**From:** [REDACTED]  
**To:** [REDACTED]  
**CC:** [REDACTED]  
**Sent:** 2/23/2021 2:35:29 PM  
**Subject:** RE: O8W-PM [REDACTED] - Bucks Creek 1101 Phase 1,2&3 - Pre-Engineering Meeting  
**Importance:** High

# Bucks Creek 1101- PM# [REDACTED] Overview Map

Subject: O8W-PM [redacted] - Bucks Creek 1101 Phase 1,2&3 - Pre-Engineering Meeting

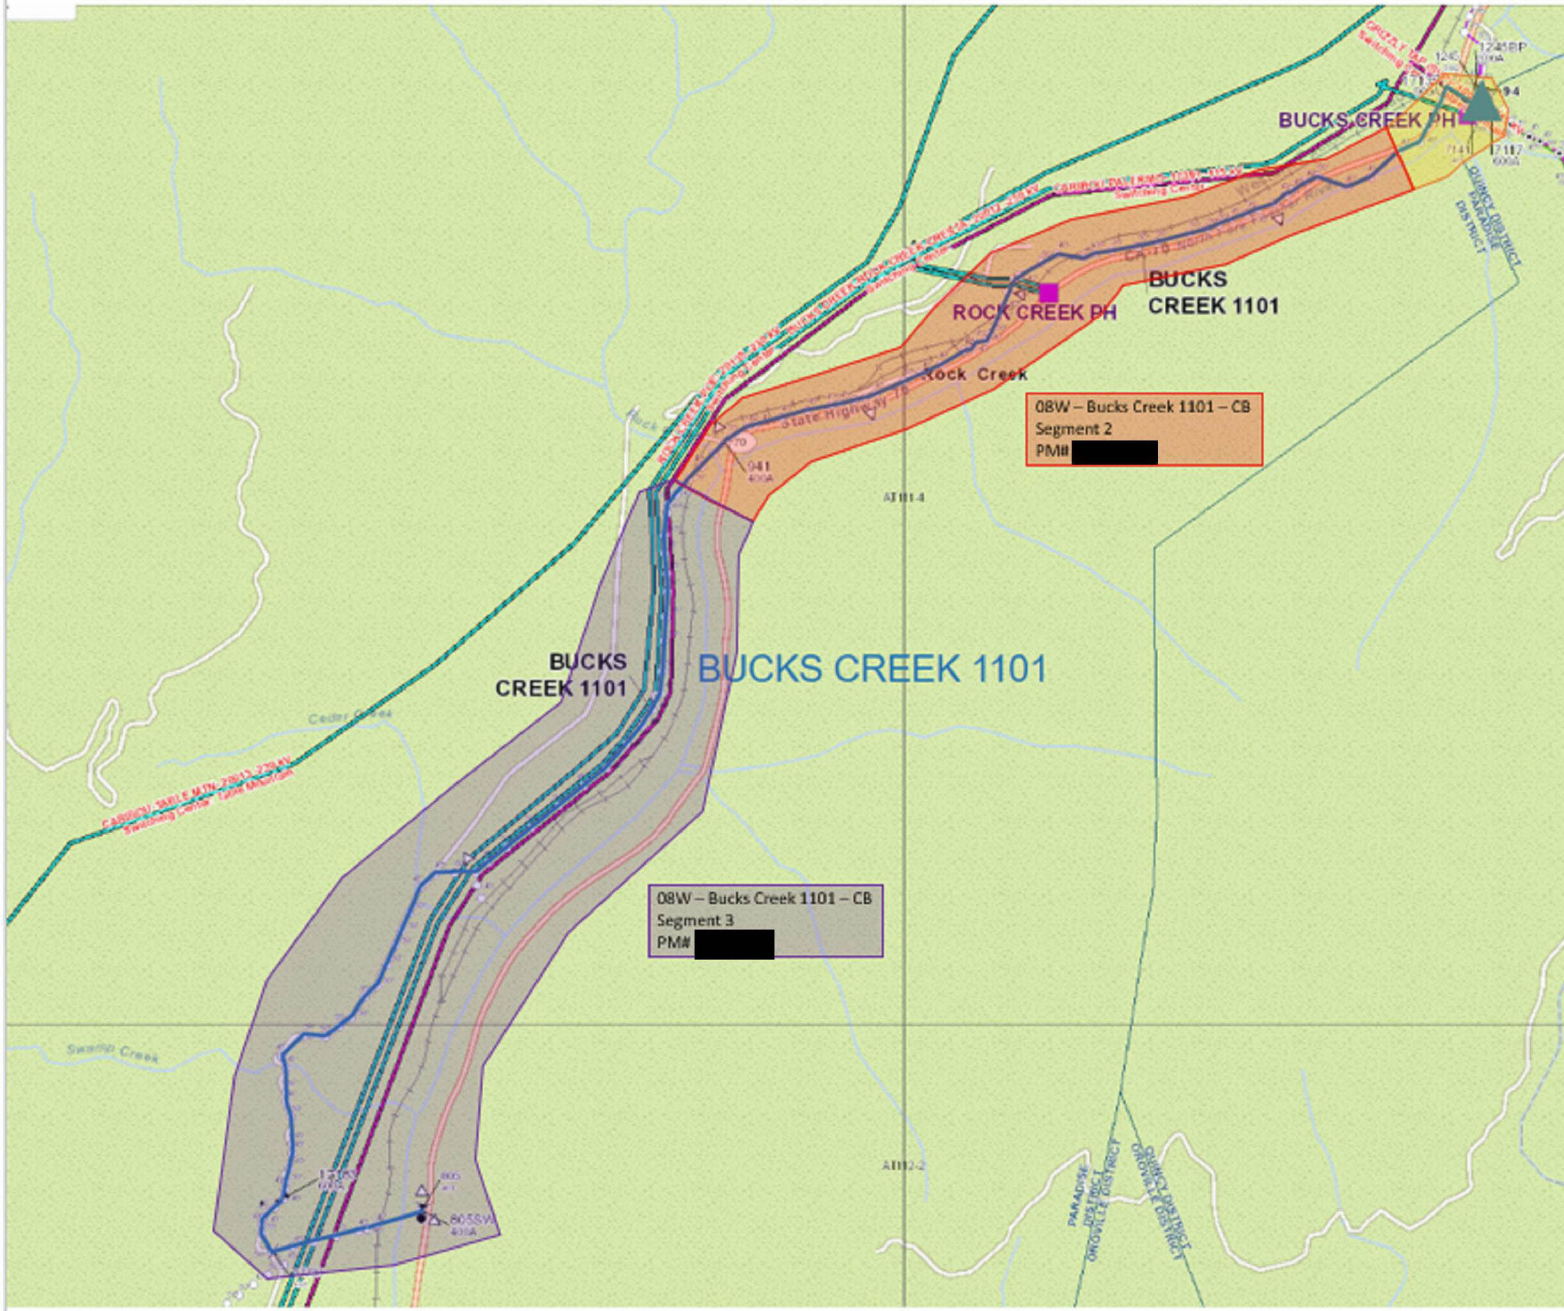
Attached are the 'base-map' limits in a kmz. file. As you will see, we need our base-map to go about ~100' into the tunnel at the south end (see pedestal in picture below....please begin about ~50 beyond this point which is about ~100' beyond the Cresta Dam).

We want to end the base-map at the sign location below which is roughly at MM (Mile Marker) 5.10.
